A-1. Proposal**Annex 3 of Informal document No. GRRF-70-05; GRRF/2011/25,
amend to read****“Warning and activation test requirements – pass/fail values**

A-2. Proposal**Annex 3 of Informal document No. GRRF-70-06; GRRF/2011/26,
amend to read****“Warning and activation test requirements – pass/fail values**

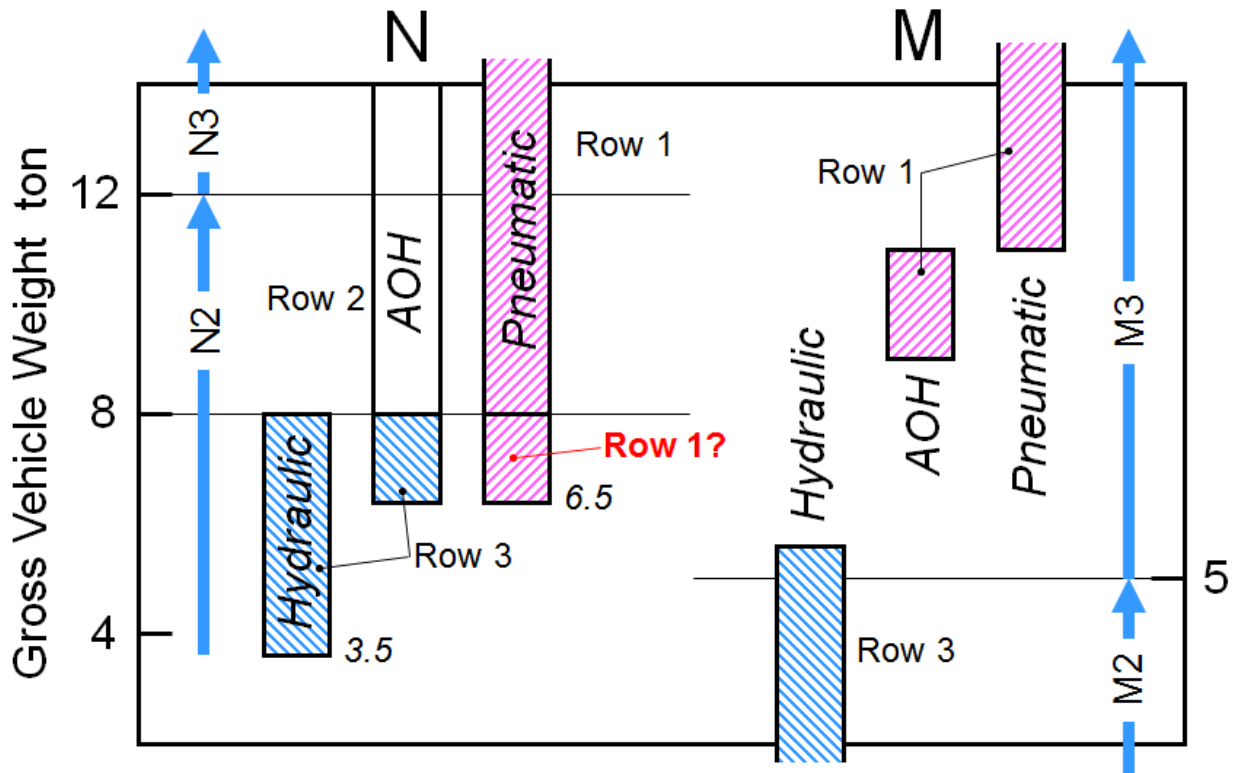
1/ Vehicles with pneumatic-hydraulic braking system (AoH) are subject to the requirements of row 2

3/ Vehicles with pneumatic braking system are subject to the requirements of row 1

~~5/ — Reservation from J for light M2/N2 vehicles~~

Vehicles with pneumatic braking system in $N_2 \leq 8t$ category are subject to the requirements of row 1, however, vehicles with pneumatic-hydraulic braking system (AOH) in the same category are subject to the requirements of row 3. Since the vehicle behaviour is according to the vehicle size, it is adequate to apply the same requirements, i.e. row 3 for both braking systems.
